TRO10032 LOWER THAMES CROSSING
COMMENTS ON APPLICANT’S SUBMISSIONS AT D7
For Deadline 8 (5th December 2023)

SHORNE PARISH COUNCIL (IP ref 20035603)

REP7-008 2.2 Land Plans Volume B (sheets 1 to 20) v7.0:

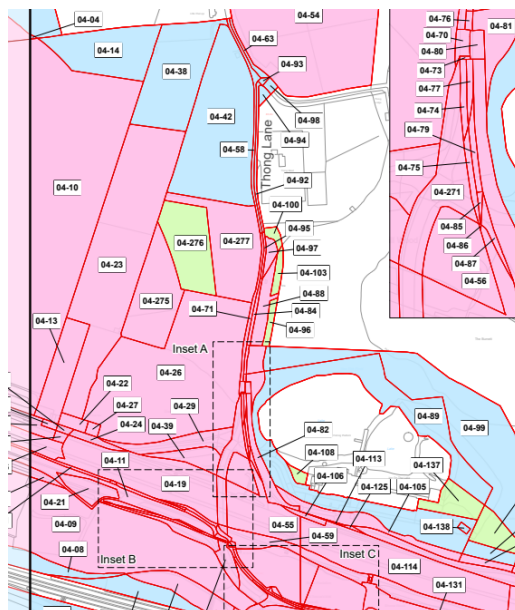
- **Future of Plot 04-276:**
 - We note on Sheet 4 that plot 04-276 is now shown as being for temporary possession.

- Information is needed about what it is to become if not being permanently acquired as it is located with the mitigation/compensation land and close to a new public right of way. If it is being returned to the original landowner, what will it be used for.
- The same applies to the plots north of the footpath.
- It had been understood that the works compound was now to be fully reinstated and landscaped, and the land become part of the total protected land post-works. If so, it would not be appropriate for this plot to be omitted.
- We would be grateful if this could be clarified as on other maps such as Sheet 19 of REP7-116 (please see below) the plot appears to be within the boundary of permanently retained land.

REP7-070 2.15 Tunnel Limits of Deviation Plans v3.0:

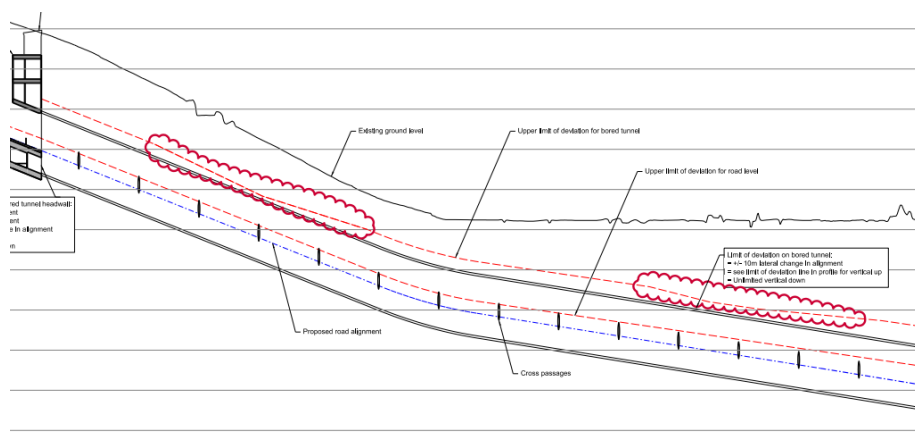
- Change to Limits of Deviation:
 - On Page 7, Sheet 2 changes are noted in the upper limit of deviation of the main bored tunnel south of the river.
 - We would expect LOD's to be shown as straight and parallel lines., which they were previously, so why have they been changed?
 - We would be grateful for an explanation as to why this change has been made and what it means for practicalities/delivery of the main tunnelling.

REP7-116 6.2 ES Figure 2.4 - Environmental Masterplan Section 2 (2 of 10) v4.0:

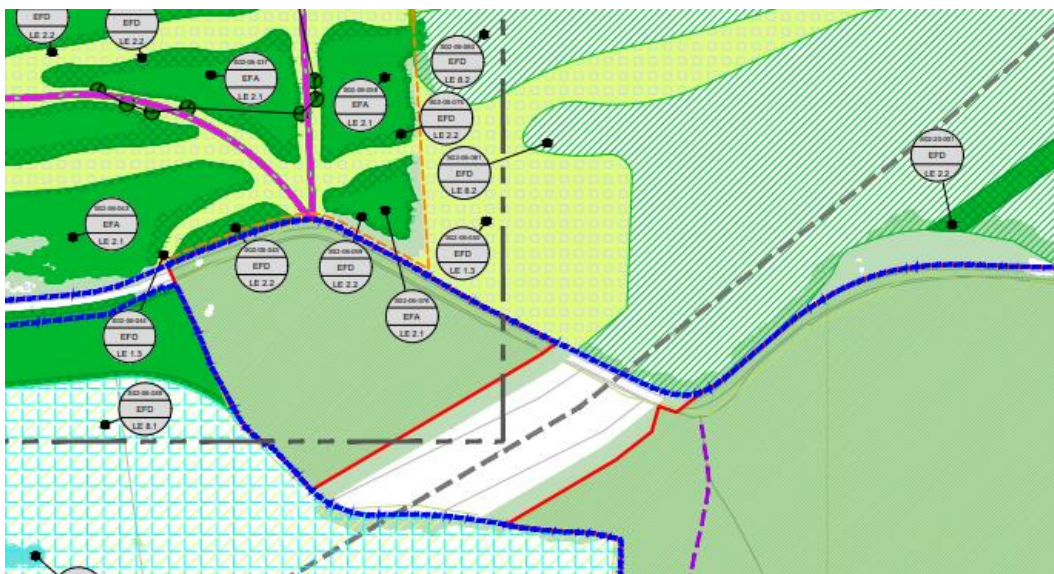
- **Remediation of Thong Lane Works Compound:**
 - Sheet 19 shows this area, including that an access road, which has gates across it, is still in place.
 - The landscaping in parts has a squared/straight edge appearance, as if it still has some intended purpose(s).
 - Further information is needed, the layout does not look very naturalistic.
 - There does not seem to be any reason why the access road and the substations should not be co-located taking the minimum possible combined footprint, and we would be grateful for this to be considered.
 - An area that is in total larger than Plot 04-276 appears to be fenced off, possibly incompletely.
 - Considerable clarification/further information is requested.

REP7-185 9.174 Deadline 7 Hearing Actions

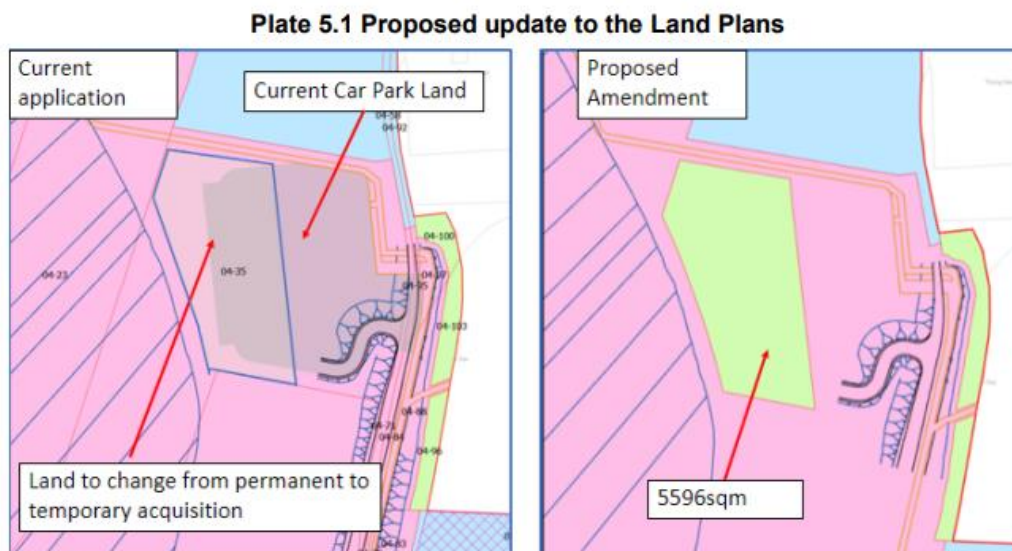
- Change of land uses, former proposed Thong Lane Car Park:
 - Please see also under REP7-008 above.
 - Plate 5.1 on page 34 shows that the Applicant is creating an area of temporary acquisition within permanent acquisition that is to be part of the landscaping of the A122 junction with the A2 and close to replacement WCH routes.

- It is hard to understand why this would be considered the correct design layout to create and how it fits in with the overall landscaping. It could be more sensible to instead make some land further away from the LTC works line temporary acquisition and return that to its landowner, e.g. for agricultural use.
- The intended future use of this land, and formal restrictions to be placed on use, need to be clarified.
